# SERVICE INFORMATION

## STANDARD AND TRIUMPH VEHICLES (NOT FOR PUBLICATION)

**No.** EIGHT/2/M SUPPRESSION OF RADIO AND TELEVISION **Date** JANUARY 1954  
(AND OTHER MODELS) INTERFERENCE

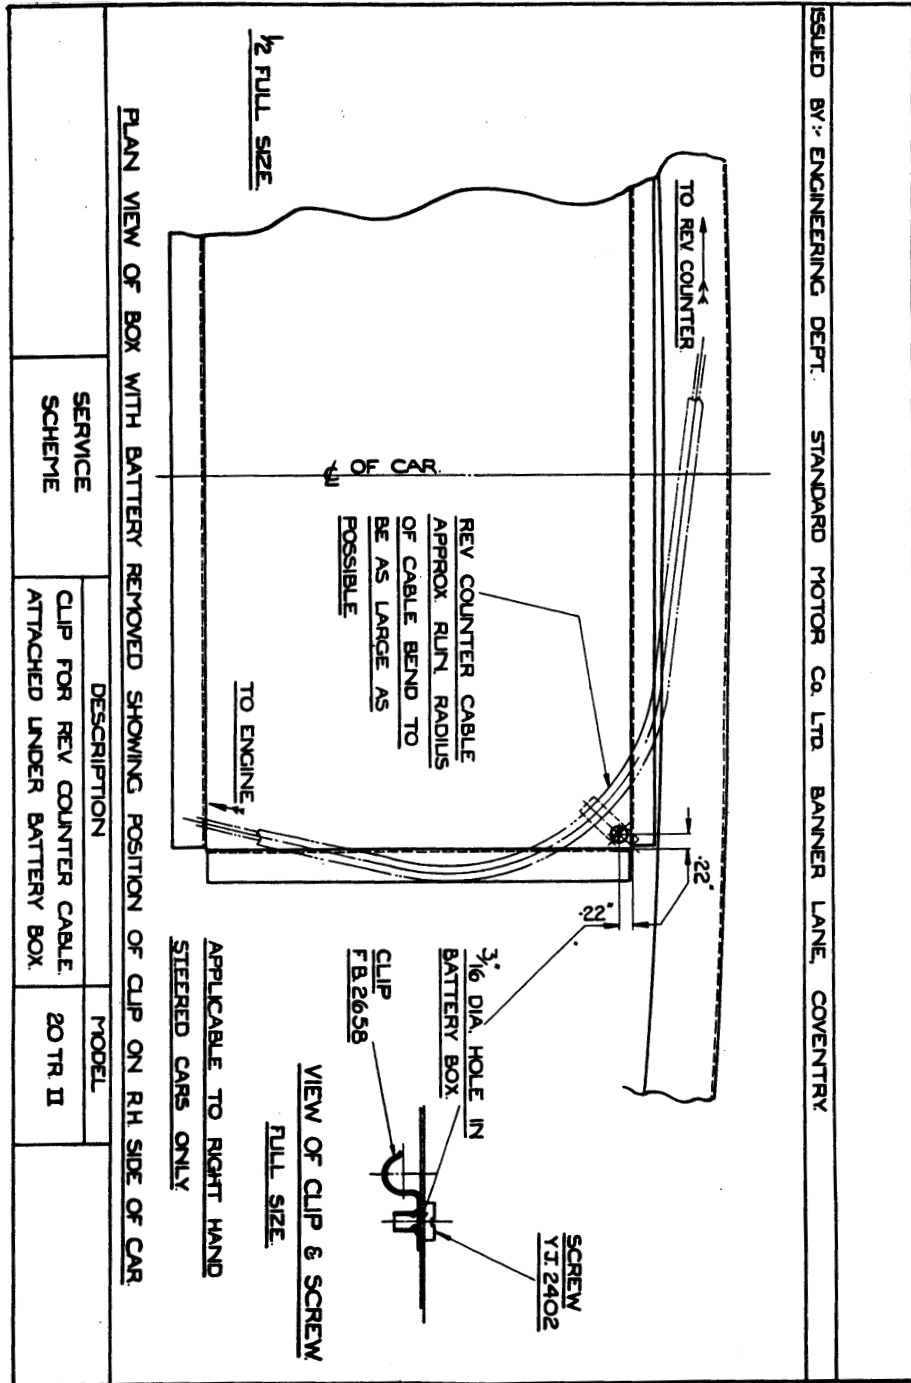
There have been cases of inner cable fracture due to sharp bends in the "run" of the outer cable on R.H.S. Models. The "run" has now been improved in factory assembly to minimise the possibility of such a condition and the modified "run" is shown in the illustration.

It is most important that both the cable for this instrument, and also that for the speedometer, are not "kinked" during installation, as once distortion of the inner cable has taken place early failure is inevitable, however correct is the subsequent run of the cable. It should be general practice to finally check the run of the cable to ensure the maximum possible radius for each bend, especially where it is "clipped" or passes through bulkheads.

1 ILLUSTRATION.

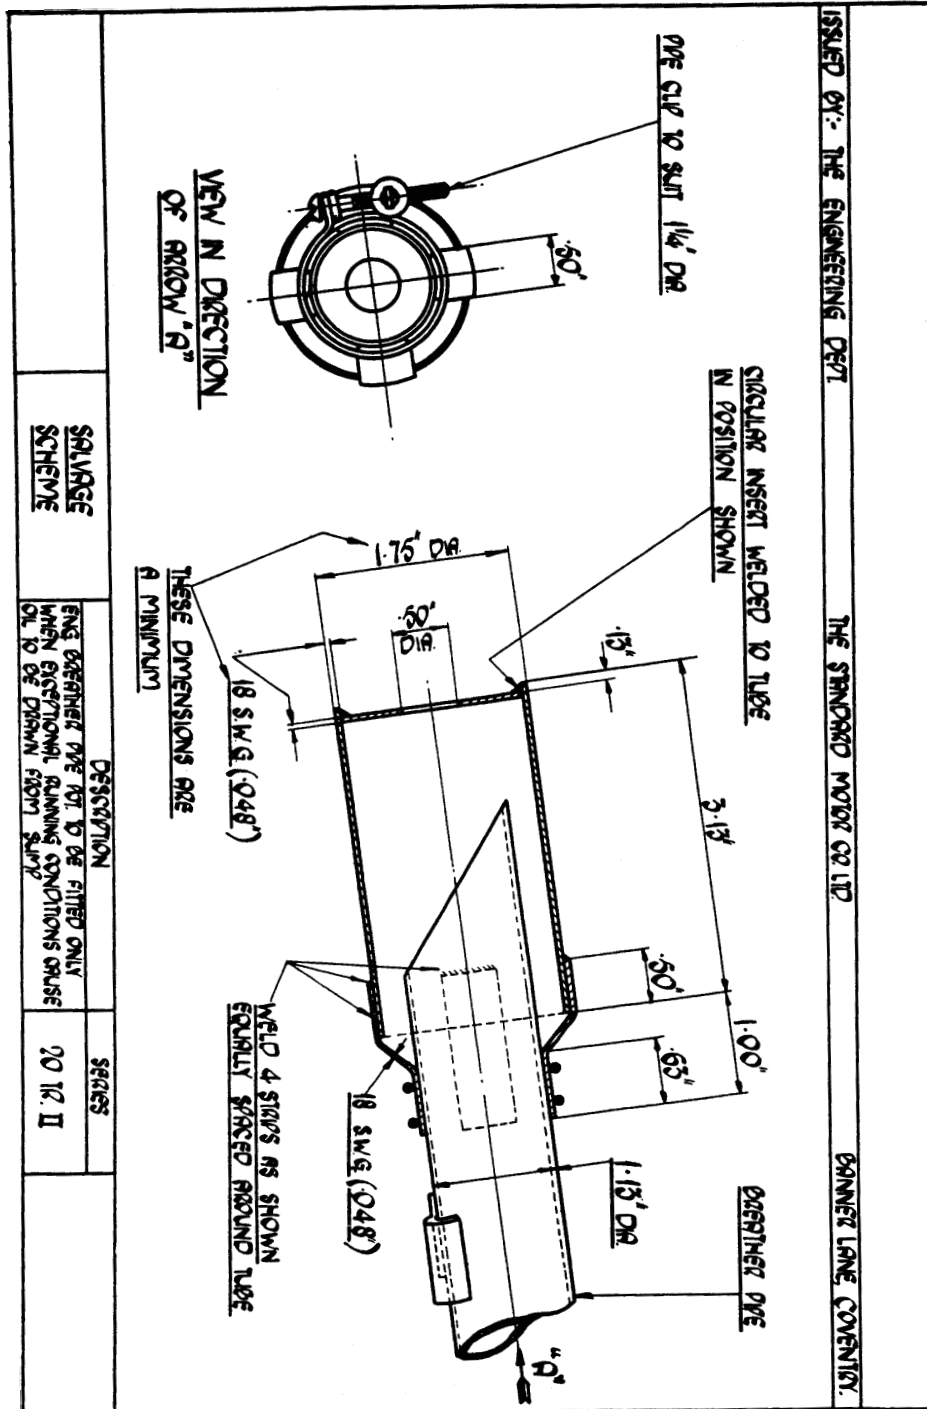
The crankcase was modified at Commission No. TS.972E. to incorporate in the casting a baffle to shield the breather pipe aperture. A new breather pipe, Part No. 202126., must be used with the modified crankcase.

To deal with complaints of excessive loss of oil at this point, with cars prior to the Commission Number quoted, the end shield shown in the illustration can be quite easily fabricated and fitted.

1 ILLUSTRATION

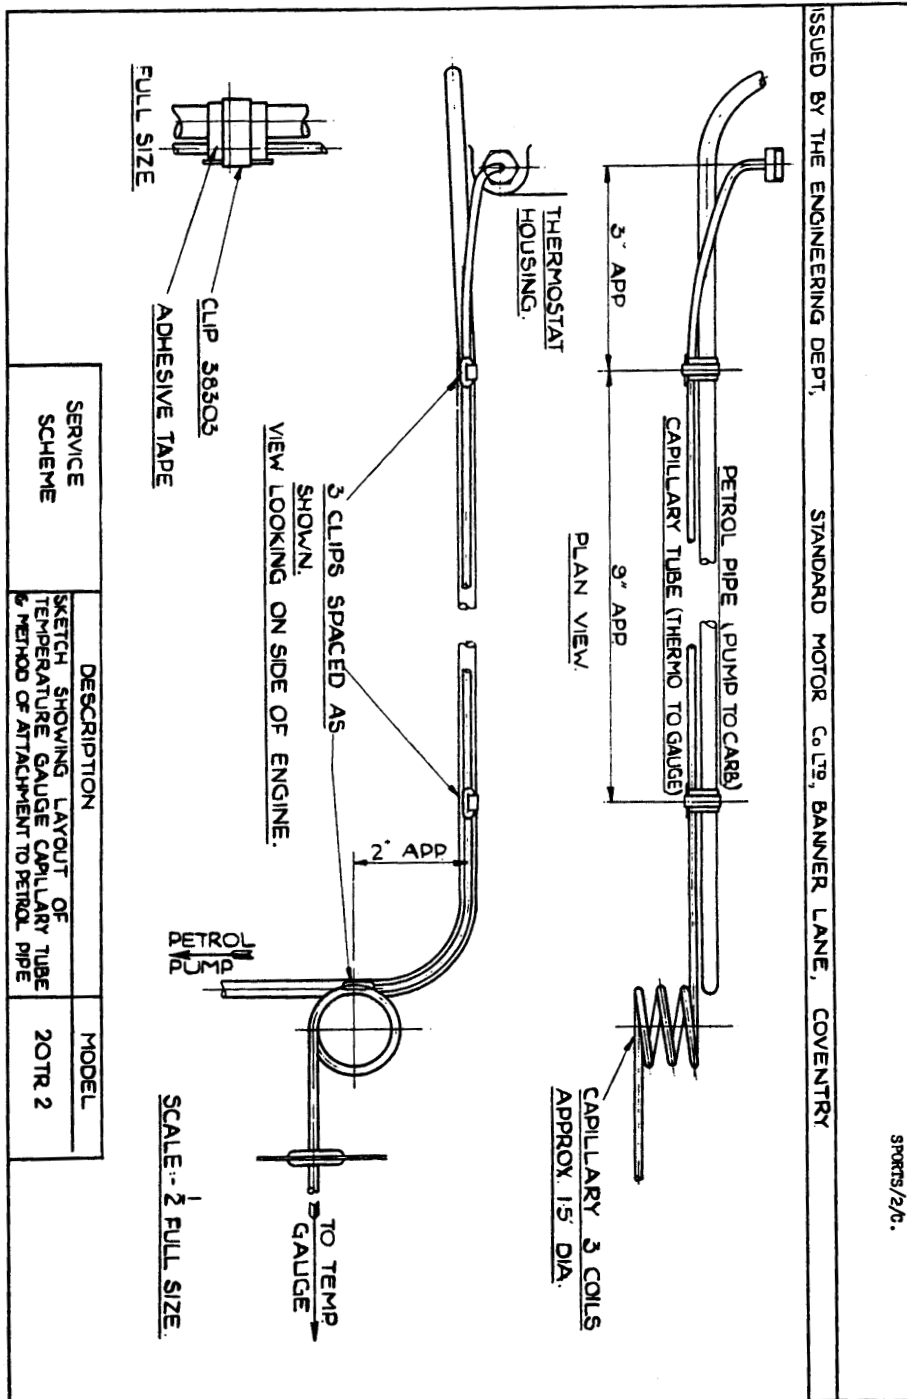
The illustration shows the correct "run" for the capillary tube when fitting replacements and should be used, where a car is found not to conform with this arrangement of the capillary tube, when carrying out normal servicing operations.

DESCRIPTION	SERVICE SCHEME SHOWING MODIFICATION NECESSARY TO ENSURE ADEQUATE ENGAGEMENT OF 2 <sup>ND</sup> GEAR.
MODEL	20. TR. 2.

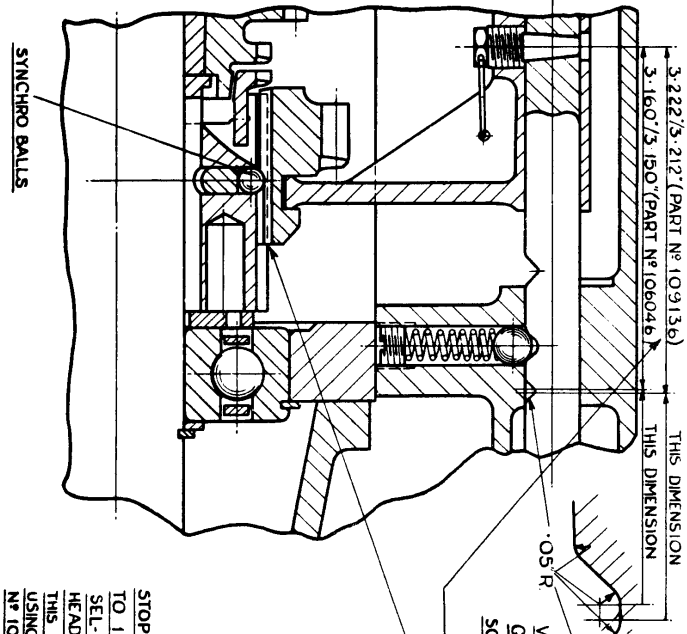
Increased depth of gear engagement has been obtained by a modified selector shaft, Part No. 109136, with an altered locating groove, but the original selector rod, Part No. 106046, may be modified as shown in the illustration.

The extra movement of the 1st. mainshaft gear, Part No. 105628, to engage more fully the “Second” gear dog teeth, will reduce the shrouding of the interlock plungers and synchro mesh balls. The effective length of the “First” gear has been increased in a modified gear under Part No. 109137 to allow for this movement.

The modified mainshaft gear was incorporated in normal production at Commission No. TS.971 and the new selector shaft at Commission No. TS.1265.

1 ILLUSTRATION.

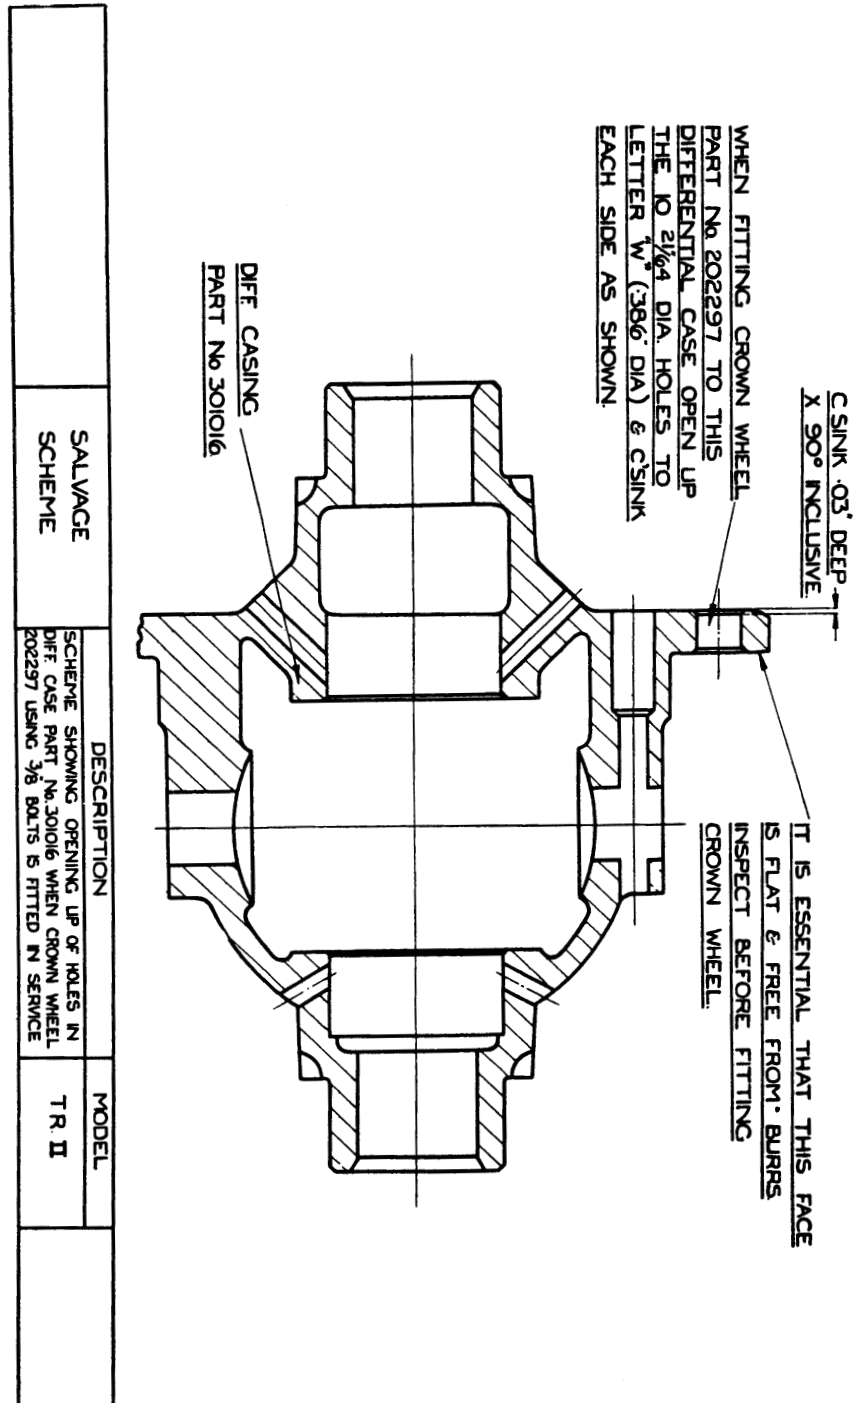
This loosening of the hubs is due to a “fretting” action between the splined locking collar and inner locating boss and has now been eliminated in production by cyanide hardening the locating collar, Part No. 108608, and increasing the size of the splines on the axle shaft with part No. 201933, to provide an interference fit.

The removal of the hubs fitted to the axle shafts which provide an interference fit will require the use of an extractor. The tools recommended for this purpose are described in Service Information Sheet SPORTS/1/Q.

1 ILLUSTRATION.

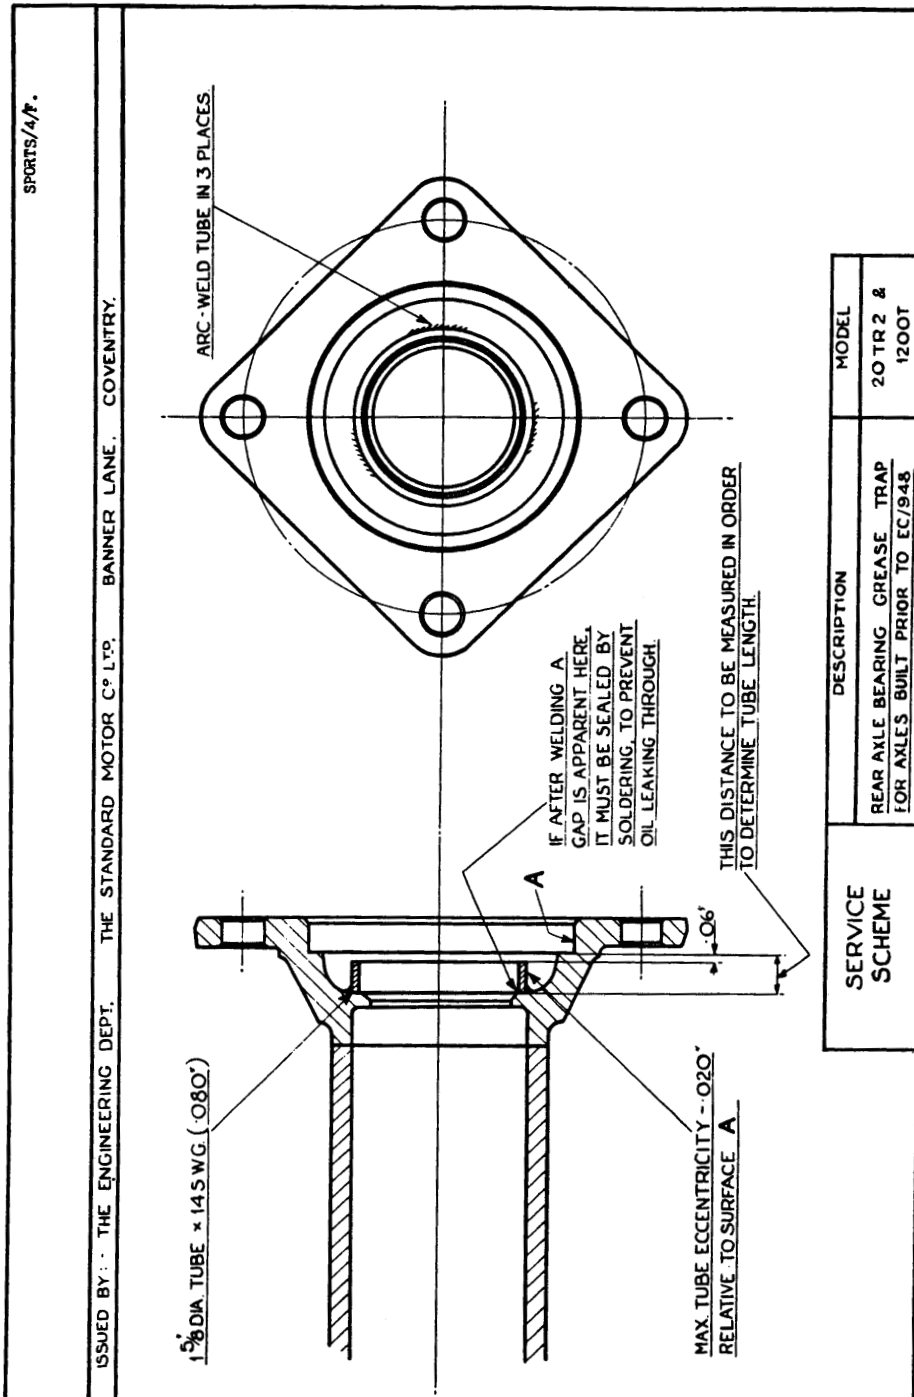
A careful investigation has been carried out, as to a possible explanation for those failures, and we are satisfied that they have been caused by the washing action of the axle oil on the grease when cornering. This washing action has left the bearing running with only a thin film of back axle oil.

Rear axles are to be modified in normal production to incorporate a grease trap similar to that shown in the illustration. This baffle serves a double purpose, it minimises the washing effect of the axle oil on the grease and ensures that a certain amount of the lubricant is always retained under the lower lip under any conditions of cornering to which the car is likely to be subjected.

This improvement can be incorporated retrospectively by modifying the axle as shown in the illustration and such an incorporation may be considered worthwhile by owners of vehicles not so equipped, using those for Rally purposes.

2 ILLUSTRATIONS.

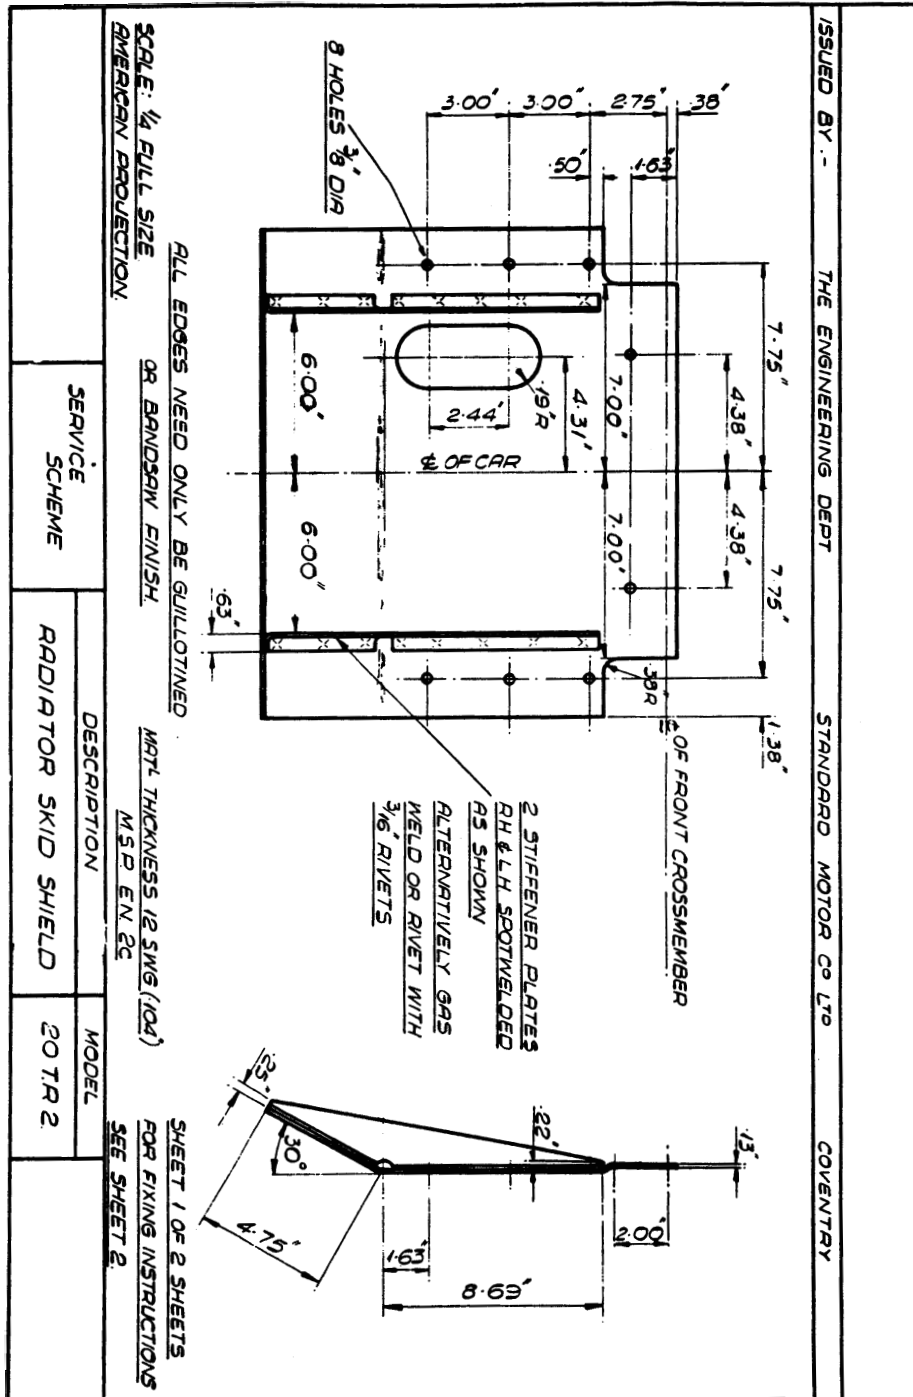
- (b) The parts should be assembled as shown in the drawing and tightened up equally on each nut to prevent alteration of the relation of the pivot with the bronze trunnion. The outer washer is also located against radial movement by self-cutting splines on the pivot pin and equal tightening should be continued until the assembly is solid.

IT IS MOST IMPORTANT THAT AFTER ADJUSTING THESE NUTS THERE IS SUFFICIENT SLACKNESS (OR END FLOAT) TO PERMIT ROTATIONAL MOVEMENT OF THE WISHBONES RELATIVE TO THE TRUNNION. IT SHOULD BE NOTED THAT THE NUTS AT EITHER END MUST BE ADJUSTED INDEPENDENTLY TO OBTAIN THIS CONDITION. THE CORRECT PROCEDURE IS TO SPANNER THE NUTS TIGHT AND THEN SLACK BACK TWO SLOTS. NUTS SHOULD THEN BE SPIT PINNED UP AND WISHBONES KNOCKED OUTWARDS BY USING A COPPER OR ALUMINIUM DRIFT THIS ENSURES THAT COLLARS ARE AGAINST NUTS THUS GIVING REQUIRED CLEARANCE.

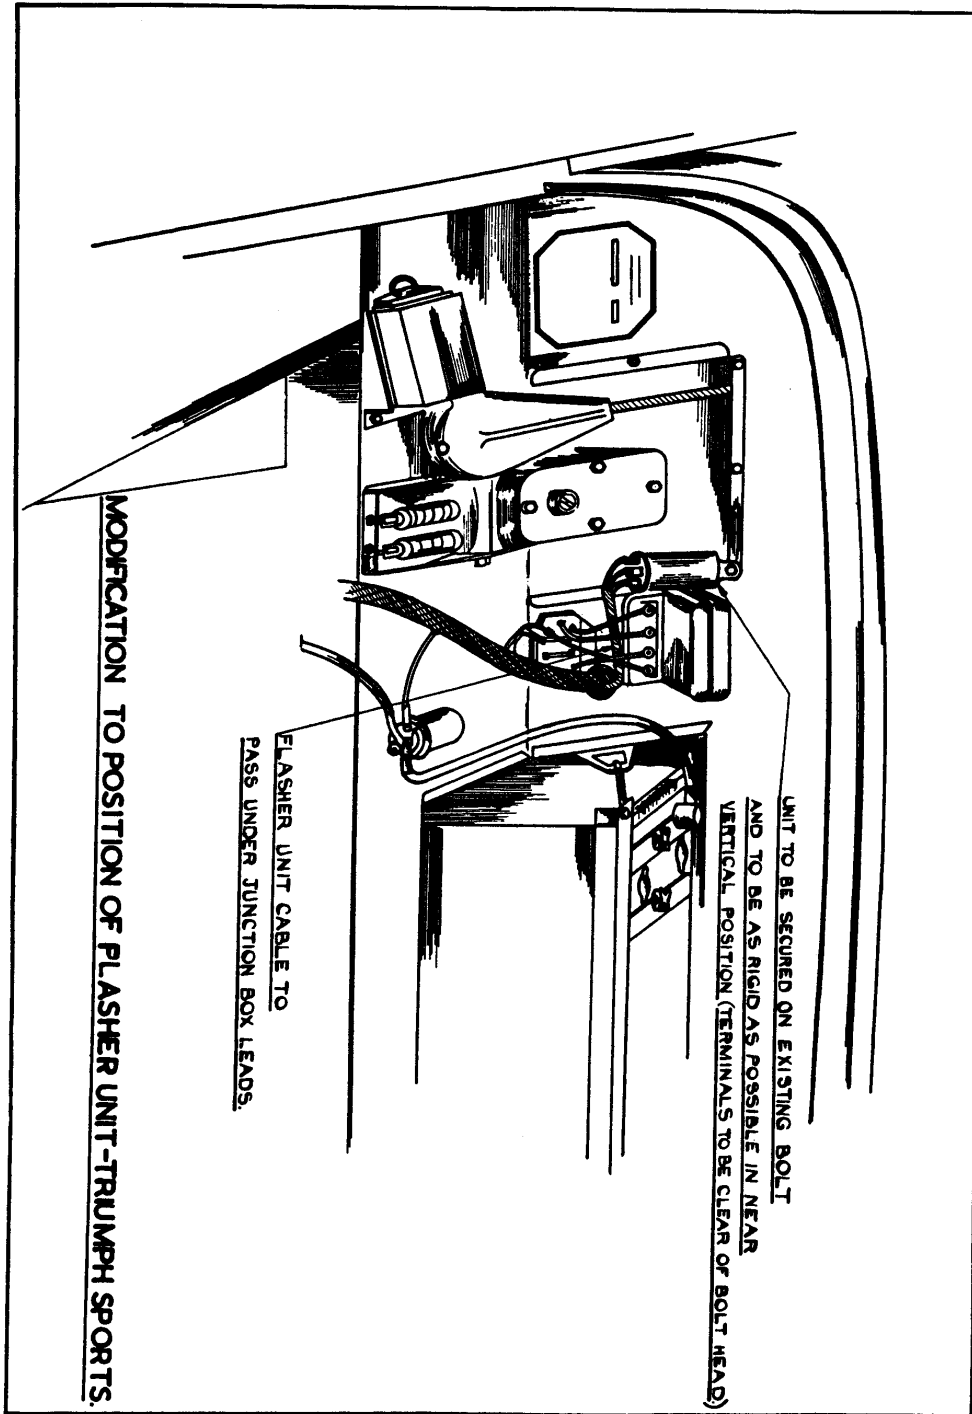
This unit is now fitted vertically (terminals pointing down the scuttle panel) and any replacement units must be fitted in this manner. It is possible to do this without modifying fixing bolts or harness and the latest position is shown in the illustration.

This change was incorporated in production during the month of February, but it is unfortunately impossible to quote a Commission Number at which the change was introduced.
